Tennessee Valley Authority, 1101 Market Street, Chattanooga, Tennessee 37402

Sequoyah Nuclear Plant, Unit 1
Facility Operating License No. DPR-77
Docket No. 50-327

Subject: Response to Nuclear Regulatory Commission (NRC) Third Request for Additional Information Regarding the Heavy Load Lifts and UHS One Time Change in Support of Unit 2 SGRP (TAC NO. ME7225)

RESPONSE TO NRC THIRD REQUEST FOR ADDITIONAL INFORMATION REGARDING THE HEAVY LOAD LIFTS IN SUPPORT OF UNIT 2 SGRP

Figure 3-259. Annual probability of exceedance of peak ground acceleration: Sequoyah site.

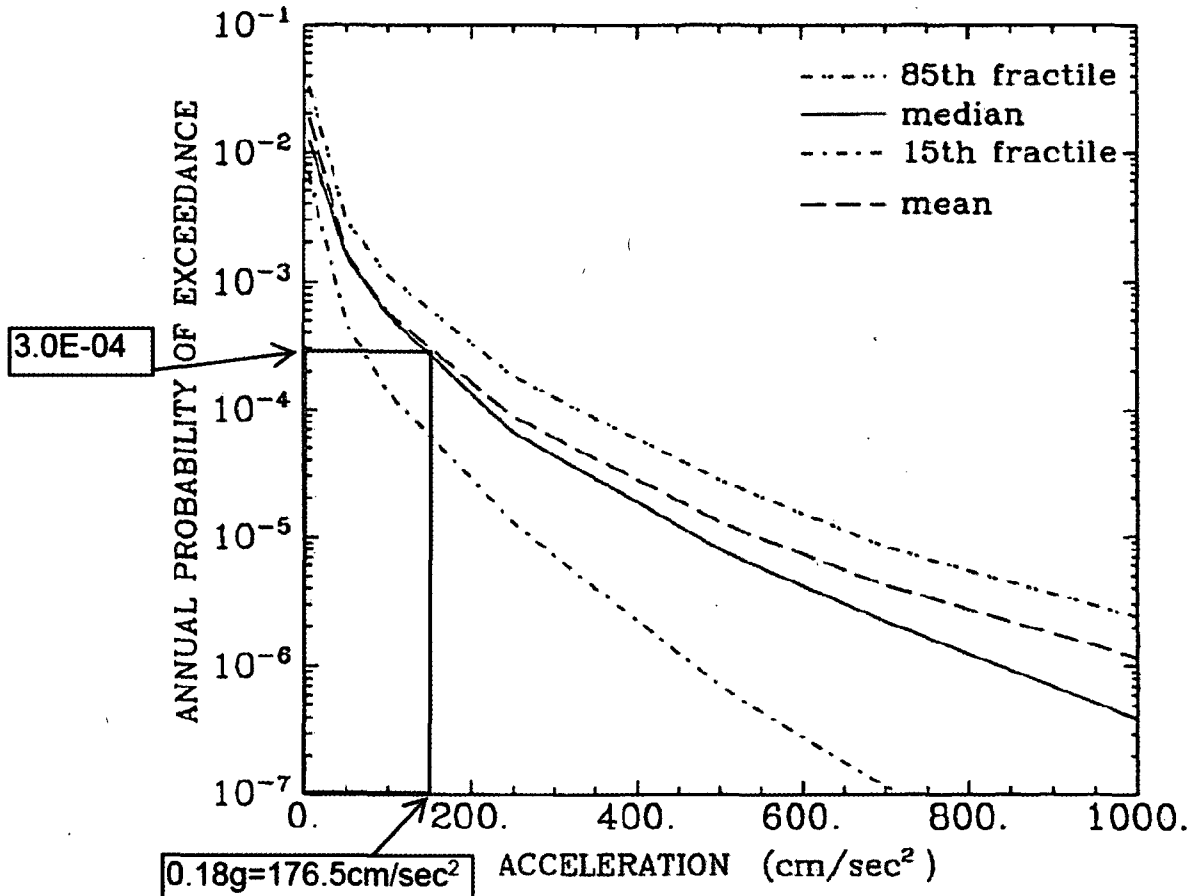
Page 31 of the submittal dated September 29, 2011 [Agency-wide Document Access and Management System (ADAMS) Accession No. ML11273A169] (submittal), states that, "the OLS [outside lift system] will not collapse or drop a load while loaded or unloaded during the SSE." What is the probability of a seismic event exceeding the SSE [safe shutdown earthquake] (or, alternatively, the strength of the OLS) while the OLS is loaded? If the risk from a seismic event could be significant compared to the random lift drop, please include this risk in your change in core damage frequency [CDF], and large early release frequency [LERF] estimates.

The Sequoyah Nuclear Plant Updated Final Safety Analysis Report (UFSAR), Section 2.5.2.4, defines the Safe Shutdown Earthquake (SSE) maximum ground acceleration of 0.18 g or 176.5 cm/sec². Using the following figure from the EPRI report NP-6995-D, "Probabilistic Seismic Hazard Evaluations at Nuclear Plant Sites in the Central and Eastern United States: Resolution of the Charleston Earthquake Issue," the frequency of a seismic event exceeding the SSE is 3.0E-04 per year.

Each load lift is estimated to take one hour to complete. Since there are eighteen load lifts, the total time during which the OLS will be loaded is eighteen hours. To calculate the probability of having a beyond SSE event while the OLS is loaded, the frequency of the seismic event exceeding the SSE ($3.0E-4$) was multiplied by the duration, in years, of the OLS being loaded ($18 \text{ hrs} / 8760 \text{ hrs per yr}$). The calculated probability of this event is $6.16E-07$. This probability is well below the annual probability of having a random lift load drop, which is $1.017E-03$, and is therefore not included in the Core Damage Frequency (CDF) and Large Early Release Frequency (LERF) analysis.
